Contract #: 04-0120F4Cty: SF/ALA Rte: 80 PM: 13.2/13.9File #: 69.25B**QUALITY ASSURANCE -- NON-CONFORMANCE REPORT****Location:** Changxing Island, Shanghai, PRC**Report No:** NCR-000134**Prime Contractor:** American Bridge/Fluor Enterprises, a JV**Date:** 14-May-2008**Submitting Contractor:** Zhenhua Port Machinery Company, Ltd (ZPMC), Changxing Island**NCR #:** ZPMC-0128**Type of problem:**

## NON-CONFORMANCE REPORT TRANSMITTAL

**Subject:** NCR No. ZPMC-0128

## NCR PROPOSED RESOLUTION

WELD NUMBER: SEG013A-007

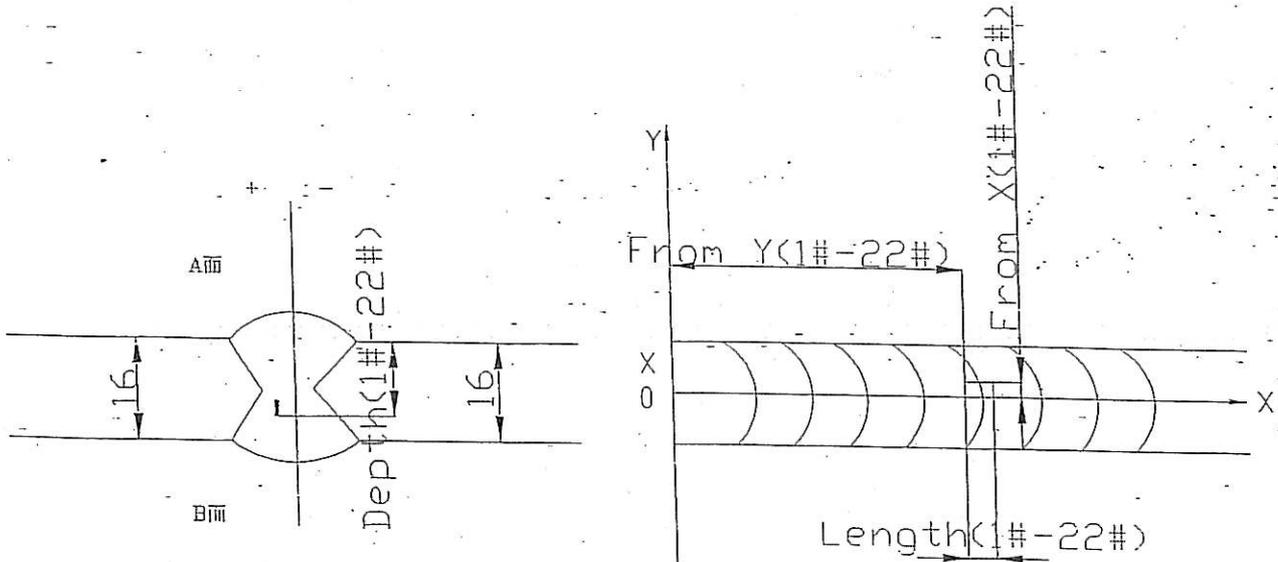
Description of welding discontinuity:

Rejected indication found by ultrasonic inspection is less than the maximum allowance aggregate length.

(UT探伤发现的缺陷总长度小于最大允许长度。) SEG013A-007

1. 从B面采用碳刨或打磨的方法去除焊缝缺陷，碳刨之前必须进行预热，温度不低于65°C;
  2. 准备正确的接头型式，具体参照返修焊接工艺规程 (WPS);
  3. 采用MT或其它无损检测方法保证缺陷完全被清除;
  4. 预热及焊接要求参照已批准的返修焊接工艺规程 (WPS) 执行;
  5. 将修补区域打磨到与母材或邻近焊缝平齐;
  6. 根据批准的车间图纸检查焊缝.
- 
1. Gouge or grind to remove all the defects from the Face B. Preheat prior to gouging to a minimum temperature of 65°C;
  2. Prepare excavation according to the approved repair WPS;
  3. Perform MT or other NDT methods of the area to insure the removal of the defects;
  4. Preheat and weld according to the relevant repair WPS;
  5. Grind the repaired area flush with base metal or the adjacent weld;
  6. Check the welds according to the working drawings.

(UT探伤发现的缺陷总长度小于最大允许长度。) SEG013A-007

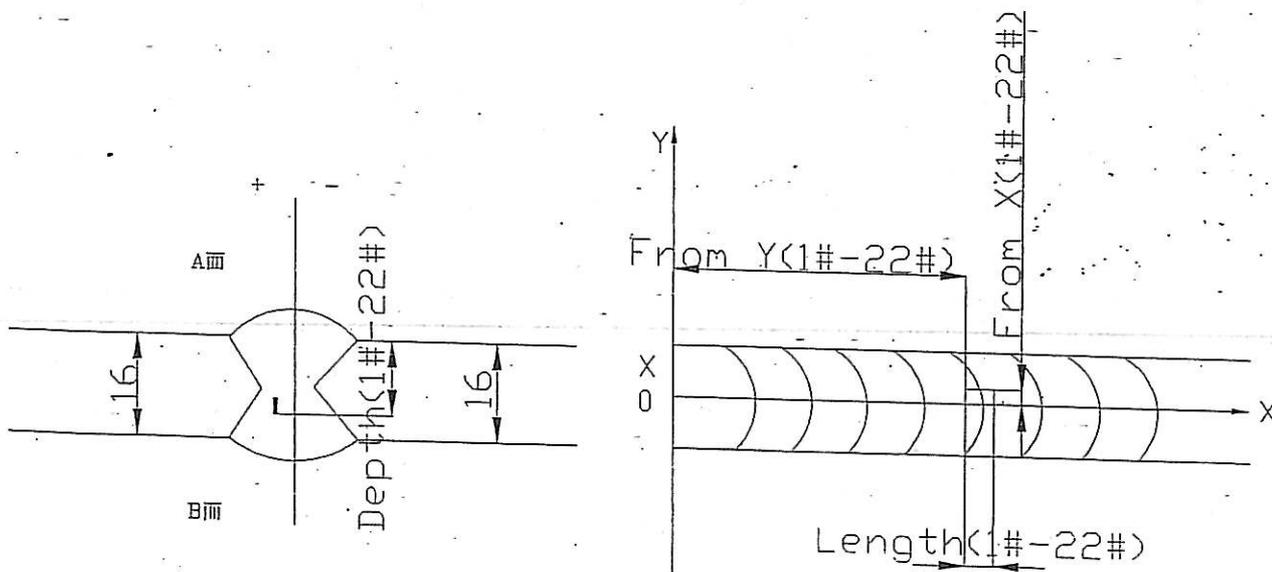
Description of welding discontinuity:

Rejected indication found by ultrasonic inspection is less than the maximum allowance aggregate length.

1. Gouge or grind to remove all the defects from the Face B. Preheat prior to gouging to a minimum temperature of 65°C;
2. Prepare excavation according to the approved repair WPS;
3. Perform MT or other NDT methods of the area to insure the removal of the defects;
4. Preheat and weld according to the relevant repair WPS;
5. Grind the repaired area flush with base metal or the adjacent weld;
6. Check the welds according to the working drawings.
